**Proposal for:
Supplement 10 to the 07 Series of Amendments,
Supplement 02 to the 08 Series of Amendments and
Supplement 03 to the 09 Series of Amendments
of UN Regulation No. 14 (Safety-belt anchorages)**

This proposal is based on informal document GRSP-73-36 and the corresponding document GRSP/2023/28 and aims at adding alternative anchorage positions to UN Regulation No. 14 in order to enable extended use positions. Amendments to the text of UN Regulation 14 are indicated in bold or strike-through. Amendments to the text of GRSP/2023/28 are indicated in blue.

“Figure 3

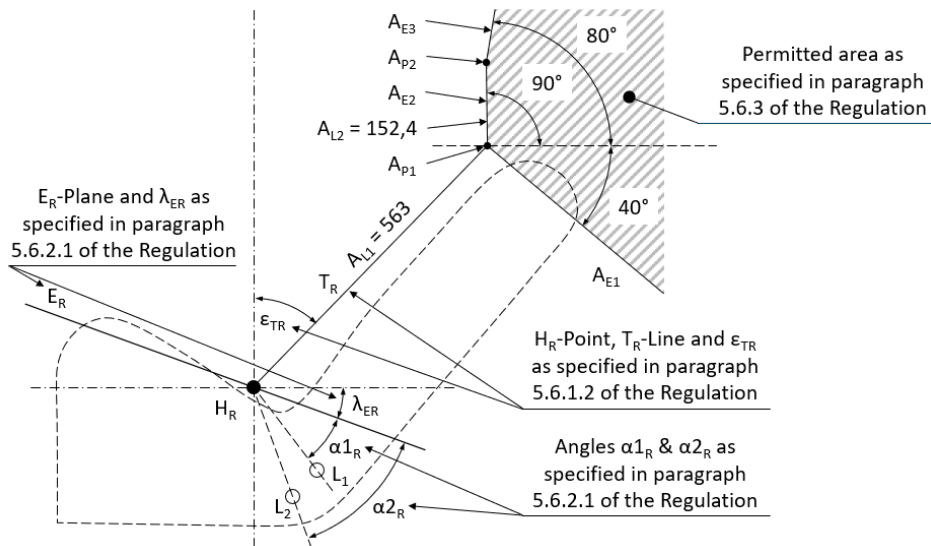
5.6.3. Location of the effective upper belt anchorages (see Figure 3 of Annex 3)

The position of the effective upper belt anchorage point(s) shall be within the permissible area shown in Figure 3 of Annex 3 to this Regulation starting from the H_R-point.

Starting from the H_R-point, the permissible area for the effective upper belt anchorage point(s) is determined with the following segment distances and planes:

- A_{L1} A segment of the torso line T_R measured in an upward direction from H_R and 563 mm long and ending in the point A_{P1};
- A_{L2} segment distance of 152.4 mm length, measured vertically upwards from the A_{P1} point and ending in the point A_{P2}

A first plane A_{E1}, inclined backwards by 40° from the horizontal, is created backwards from point A_{P1}.

A second plane A_{E2} is created perpendicular to the longitudinal ~~center~~ **centre** plane of the seat between points A_{P1} and A_{P2} .

A third plane A_{E3} , inclined horizontally by 80° forwards, is created backwards from point A_{P2} .

The permissible area for the effective upper belt anchorage point(s) is located behind the three planes A_{E1} , A_{E2} and A_{E3} .

Areas of location of effective belt anchorages according to paragraph 5.6.2 and 5.6.3 of this Regulation for extended use positions

“Figure 4

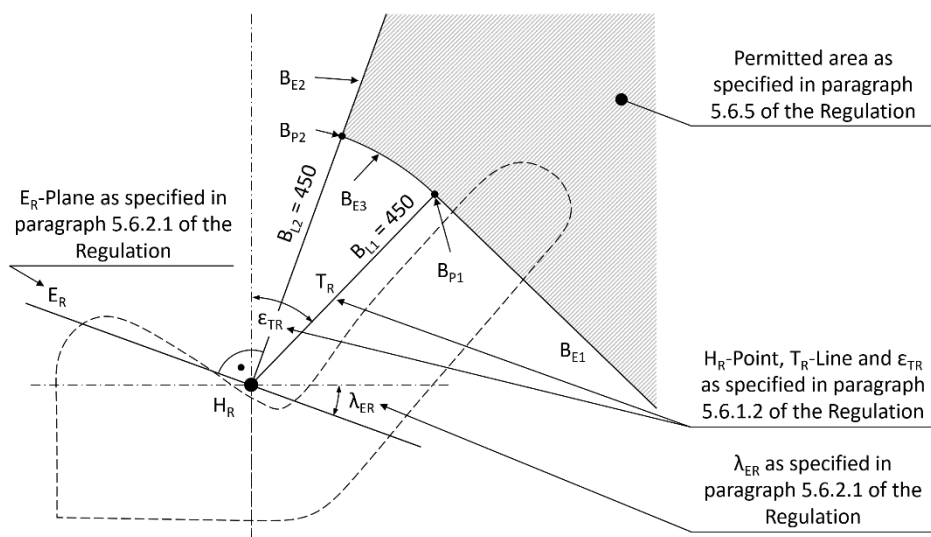
During the test referred to in sub-paragraph (a) and (b), the effective upper belt anchorage point(s) shall be within a permissible area specified in Figure 4 of Annex 3 of this Regulation. For the purpose of this test, the seats may also be in extended use positions as described in paragraph 6.1.2 of this Regulation.

Based on the H_R -point, determine the permissible area shown in Figure 4 of Annex 3 to this Regulation for the effective upper belt anchorage point(s) during the test with the following segment sections and planes:

B_{L1} A segment of the torso line T_R measured in an upward direction from H_R and 450 mm long, ending with the point B_{P1}

B_{L2} A segment distance of 450mm length, measured from the H_R -point perpendicular to the E_R -plane upwards, ending with the point B_{P2}

A first plane B_{E1} is created backwards perpendicular to the torso line T_R and perpendicular to the longitudinal ~~center~~ **centre** plane of the seat at point B_{P1} .

A second plane B_{E2} is created upwards perpendicular to the E_R -plane and perpendicular to the longitudinal ~~center~~ **centre** plane of the seat at point B_{P2} .

A shell surface B_{E3} is created with a radius of 450mm in the H_R -point between the points B_{P1} and B_{P2} perpendicular to the longitudinal ~~center~~ **centre** plane of the seat.

The effective upper belt anchorage point(s) shall not move below or in front of the planes B_{E1} and B_{E2} as well as shell surface B_{E3} during the test. “

Permitted area of location for upper effective belt anchorages according to paragraph 5.6.5 of this Regulation for other use positions than normal ones

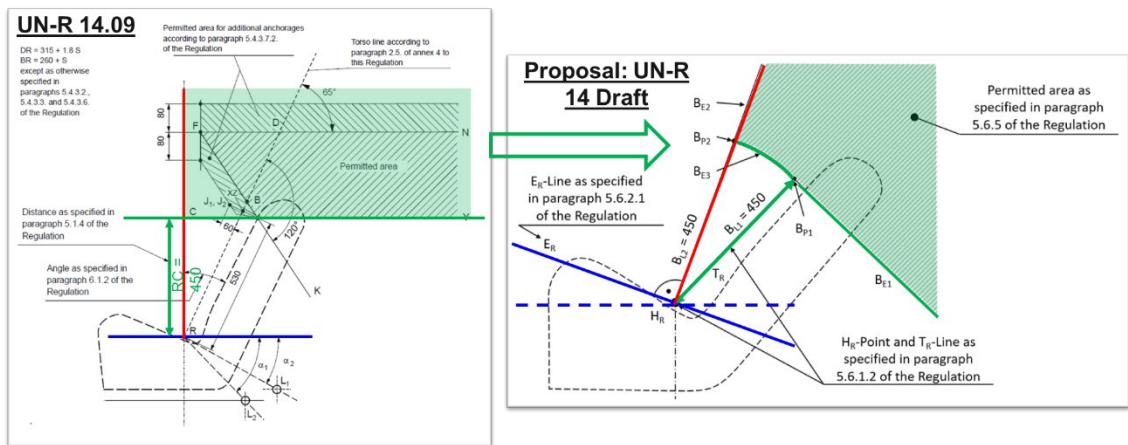
For the permitted area before the test the upper area is based on FMVSS 210 as this would enable sufficient mounting positions even when the seatback has a higher inclination.

For the permitted area during and after the test, a new area must be defined for the upper belt anchorages as otherwise the current provisions regarding the CY-line can very likely not be fulfilled. The idea is to create a permitted area, whose lower boundary is limited to a distance of min. 450 mm around the HR point.
